Title: Exergy and Energy Analyses of Dual-temperature Evaporator Split AC System Incorporated a Capillary Tube and a Two-phase Ejector

Decision: Major revisions

Response to Reviewers' comments

Fig. 1. a) Constant-area mixing ejector and b) Constant pressure mixing ejector (Keenan et al., 1950)

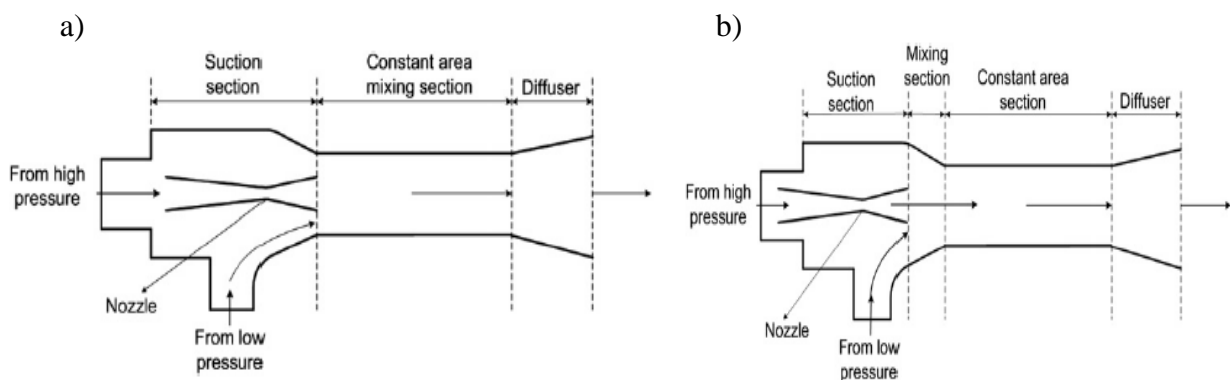
Comment 2: Can you explain physically the difference between the two types of the two-phase ejectors (constant pressure ejector and constant area ejector) 4th paragraph of the introduction?

Re: Yes, we can. Our explanation is as shown below. We do not include the explanation in the manuscript. However, we have added an indication and a reference where the explanation of physical differences between the two ejectors can be found. A new reference has also been added as reference [9] Keenan, J.H., Neuman, E.P., Lustwerk, F." An investigation of ejector design by analysis and experiment". ASME Journal Applied Mechanics. 17 (1950): 299-309.

The physical differences of the constant area and constant pressure ejectors have been explained by Keenan et al. (1950). The two ejectors have different mixing section. The first ejector has a constant area mixing section as shown in Fig. 1a, but the second ejector has a constant pressure mixing section (Fig. 1b).

Additionally, a constant area ejector (Fig. 1a) comprises three main sections which include: suction section, mixing section with constant area and diffuser. Mixing between high-pressure primary flow and low-pressure secondary flow occurs in the constant mixing area. This is because the end of the nozzle is placed right on the inlet side of the constant section region so that the mixing of the refrigerant occurs in the constant region. While a constant pressure ejector (Fig. 1b) consists of four main sections, namely: suction section, mixing section with varied sectional area of constant pressure, constant area section and diffuser. The end of the nozzle is placed within the suction section. Mixing between high-pressure primary flow and low-pressure secondary flow, therefore, occurs in the mixing area which is part of the suction section.

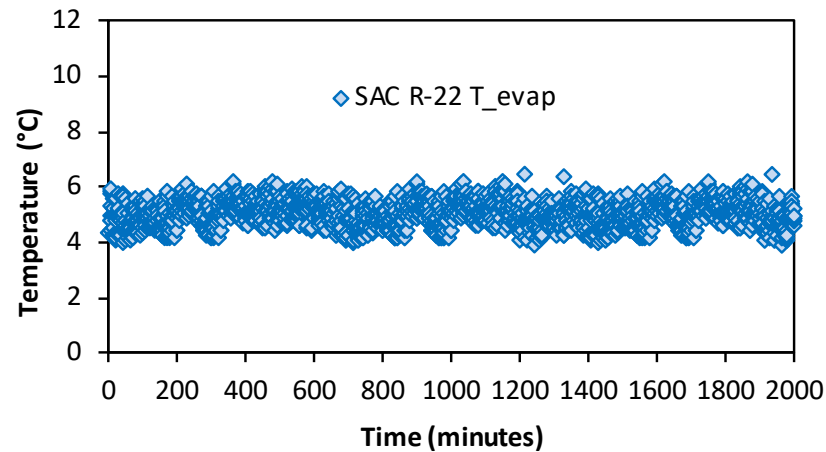
Comment 8: In the section 3.1.1: The authors said: “The primary and secondary coil evaporation temperatures of $11.4 \text{ }^\circ\text{C}$ and $7.8 \text{ }^\circ\text{C}$ respectively show that overall temperature evaporation of the COS-SAC system is significantly higher than SAC system which commonly ranges from 4 to $6 \text{ }^\circ\text{C}$ ”. Why the evaporation temperature of the SAC system is not shown in Fig. 3?

Re: Fig. 3 is intended to mainly illustrate the evaporation temperature variation of the dual evaporator temperature system. Therefore, the graphs can clearly show the difference

between the primary and the secondary evaporator temperatures. Due to limitation of the space in the paper and also it has been a common sense that evaporation temperature of an SAC system for comfort purposes ranges from 4 to 6 °C. That is why the evaporation temperature of the SAC system is not shown in Fig. 3. For your information, the following graph shows the variation of evaporation temperature of the SAC R-22 system.
